Applicant : Klayman
Appl. No. : 09/185,876
Filed : November 3, 1998
For : VOICE INTELLIGIBILITY
ENHANCEMENT SYSTEM
Examiner : M. Opsasnick
Group Art Unit : 2655

SUBMISSION OF PROPOSED DRAWING AMENDMENTS FOR APPROVAL BY THE EXAMINER

FIG. 1C

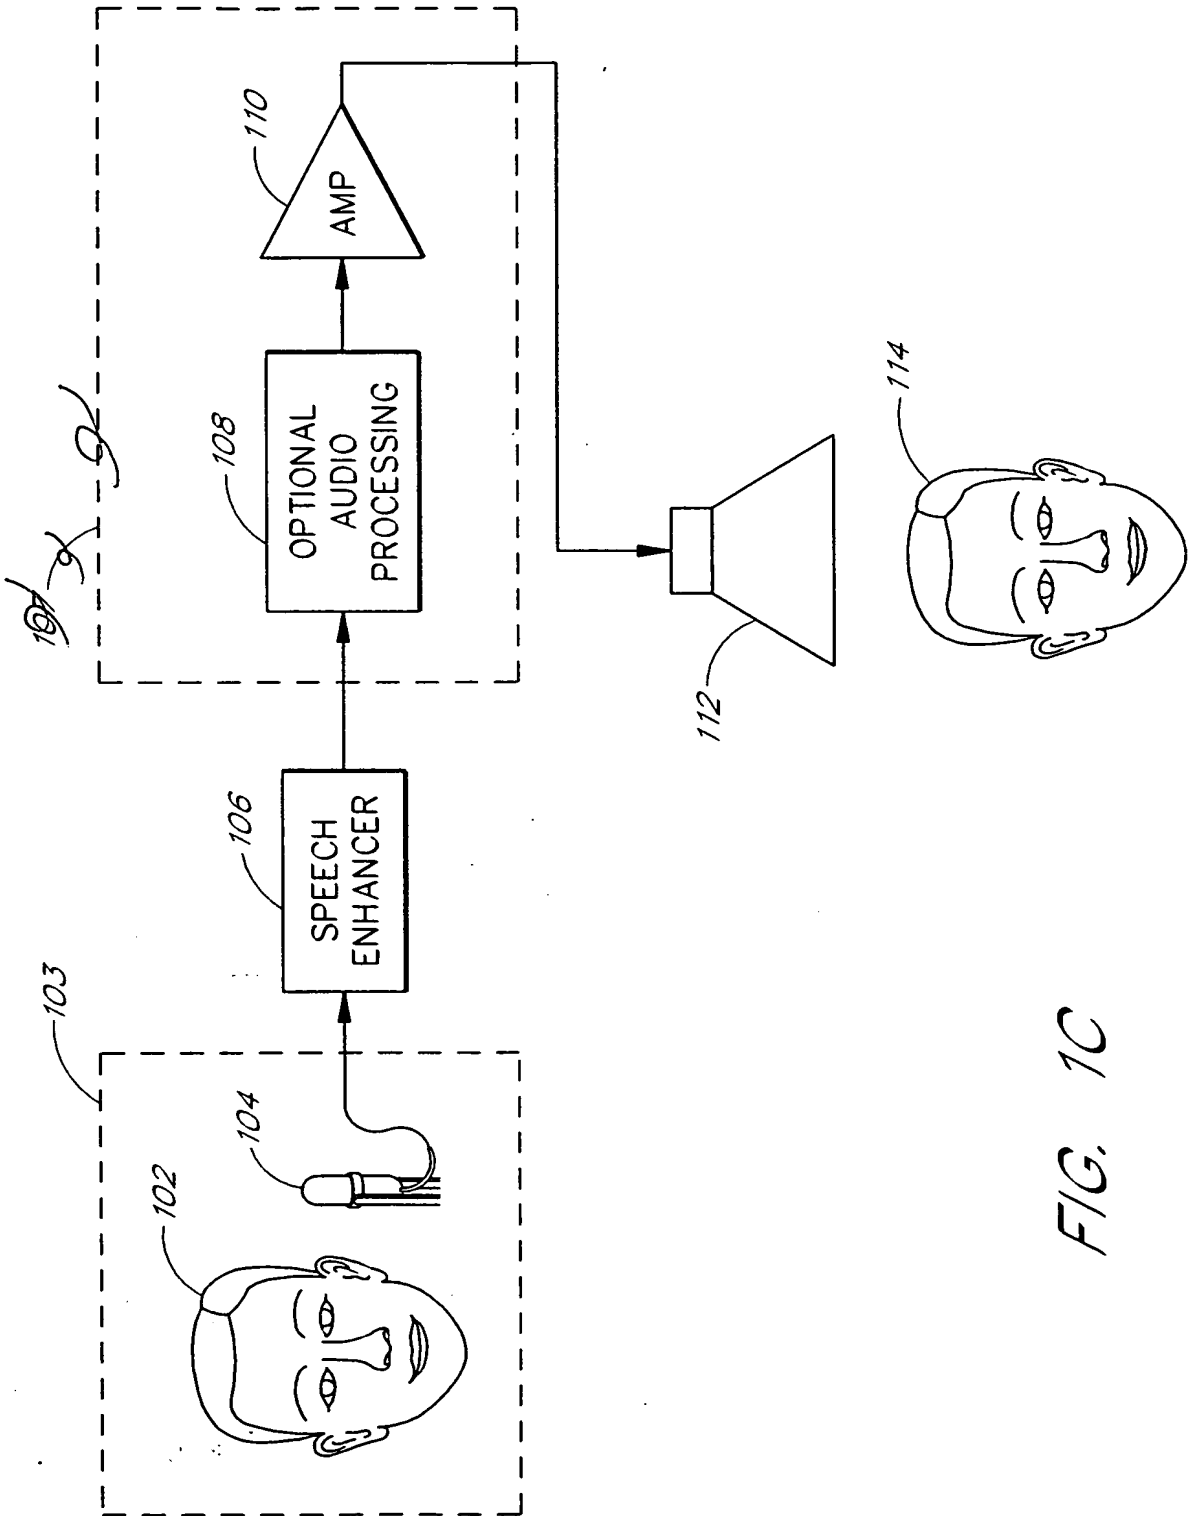
In Figure 1C, please remove reference indicator 107 and the dashed box surrounding items 108 and 110, as shown in RED.

Applicant respectfully submits that the proposed drawing changes do not introduce new matter. In Figure 1C, reference items 108 and 110 were incorrectly surrounded by a dashed box and the dashed box was incorrectly labeled 107. Applicant has removed the dashed box and the reference indicator 107. There is no reference to reference number 107 with respect to Figure 1C in the specification.

FIG. 9B

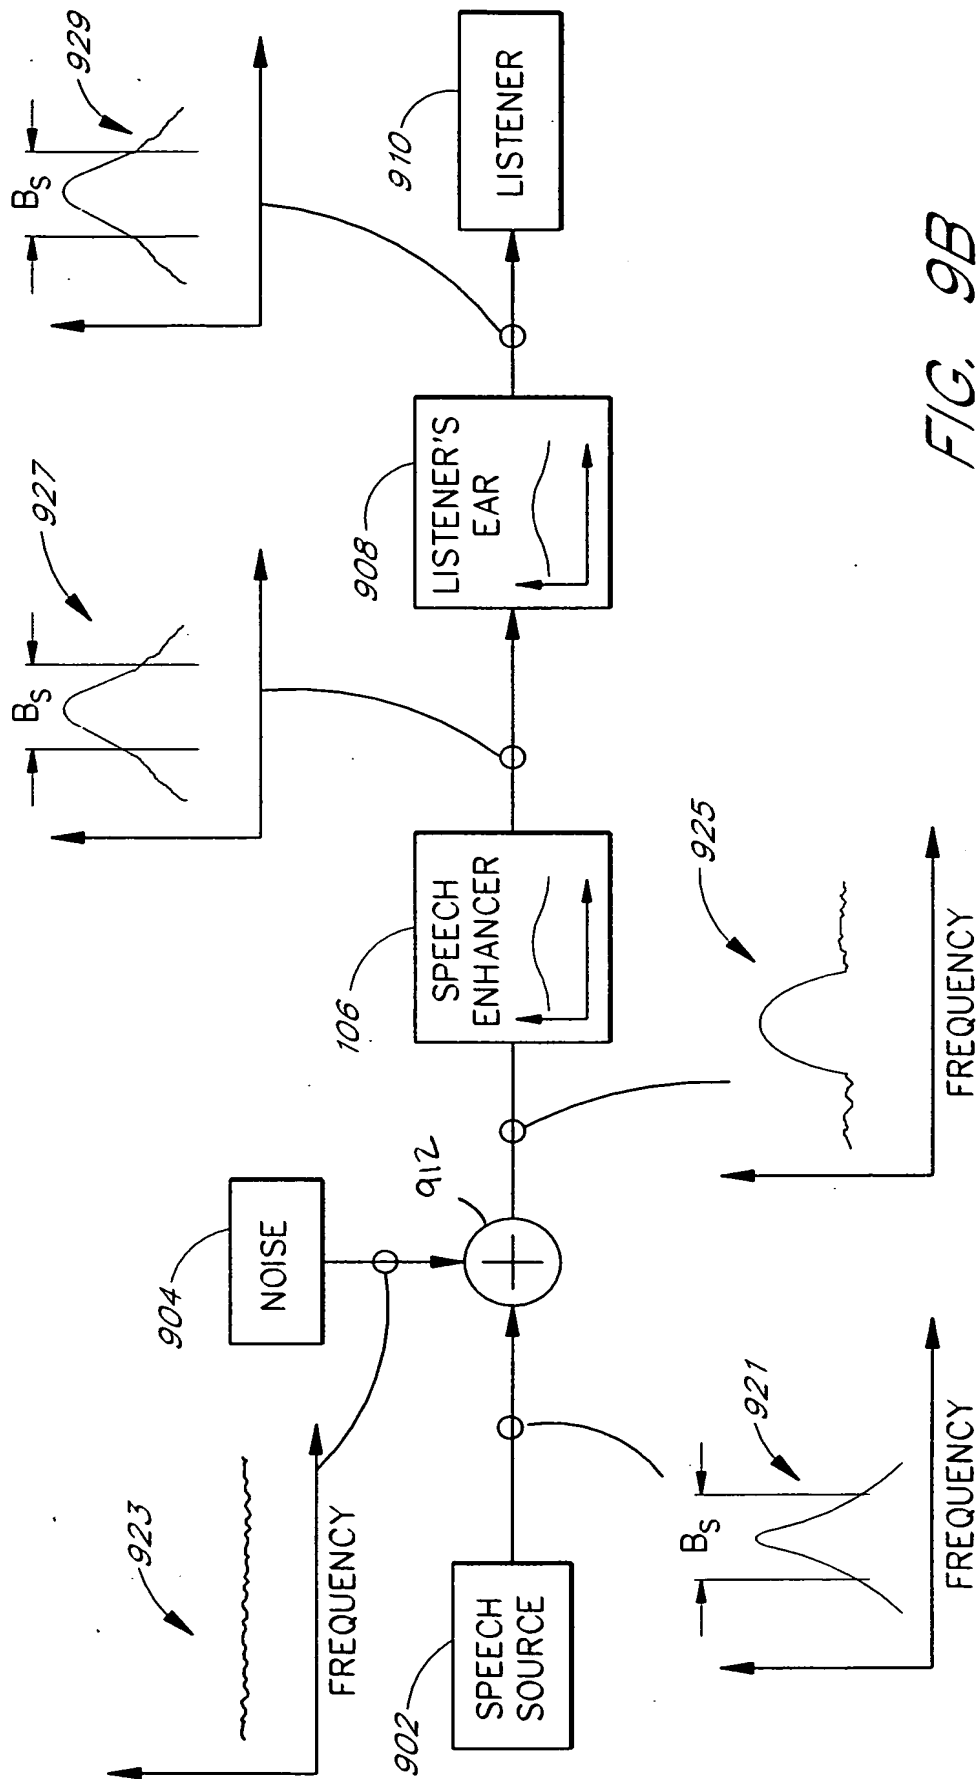
In Figure 9B, please add reference indicator 912, as shown in RED.

The paragraph beginning on page 20, line 27 provides support for the change to Figure 9B. The paragraph beginning on page 21, line 14 and the paragraph beginning on page 21, line 22 provide support for the change to Figure 9C. The paragraph beginning on page 22, line 9 provides support for the change to Figure 9D.

FIG. 9C

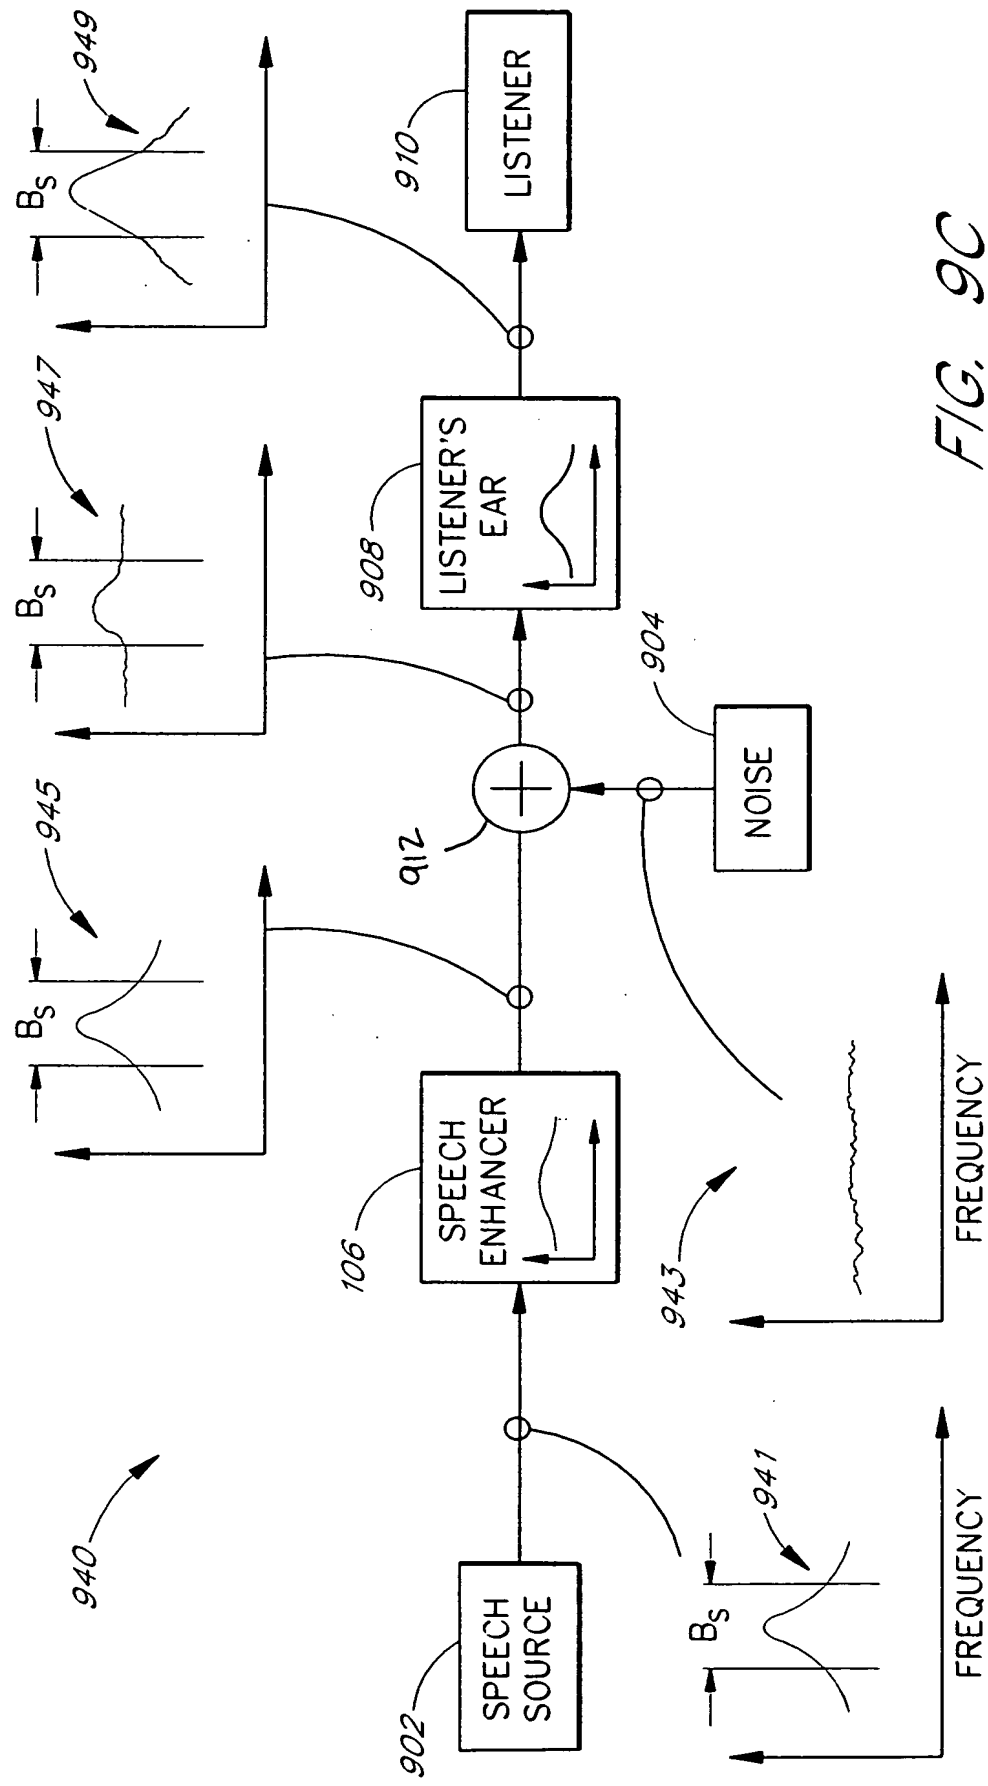
In Figure 9C, please add reference indicator 912, as shown in RED.
